UNITED STATES PATENT AND TRADEMARK OFFICE

APPLICATION NO.	FILING DATE	FIRST NAMED INVENTOR	ATTORNEY DOCKET NO.	CONFIRMATION NO.
10/027,080	12/20/2001	John Laurence Minck JR.	267/166	9793

Office Action Summary	Application No. 10/027,080	Applicant(s) MINCK ET AL.	
	Examiner Jessica R Baxter	Art Unit 3731

DETAILED ACTION

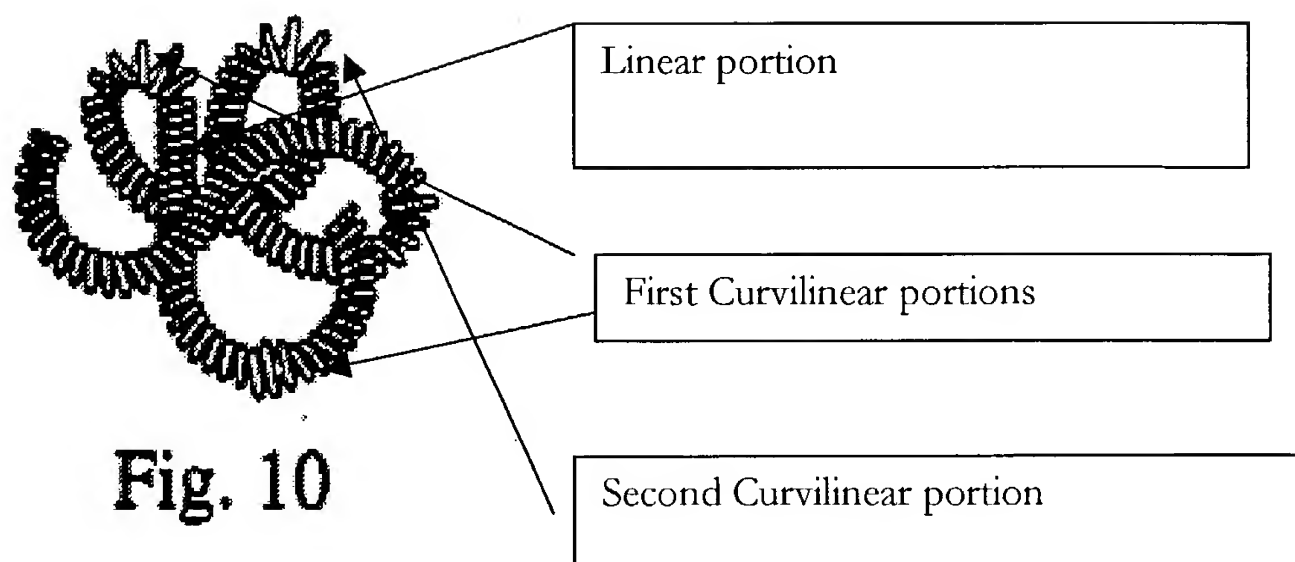
Kurz discloses that the first curvilinear portion has a first peak and the second curvilinear portion has a second peak, and a first line connecting the first peak and the

second peak does not intersect a second line extending between the first and second ends (FIG. 3).

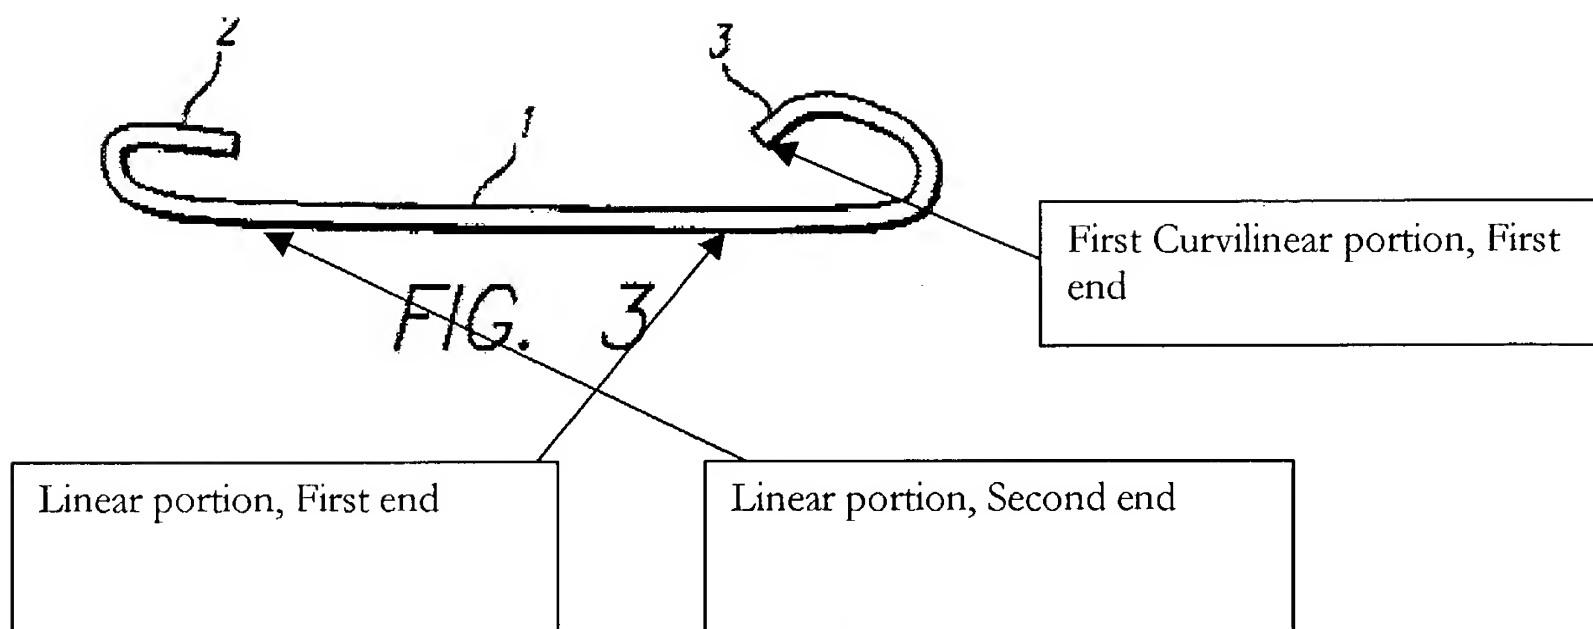
9. Applicant's arguments filed July 16, 2004 have been fully considered but they are not persuasive.
10. Applicant argues that Kurz et al. '015 does not disclose "the second end of the linear portion is located closer to the second end of the first curvilinear portion than a first end of the first curvilinear portion when the member is in a relaxed configuration." Please see the attached Figure 3, for how this limitation is met.
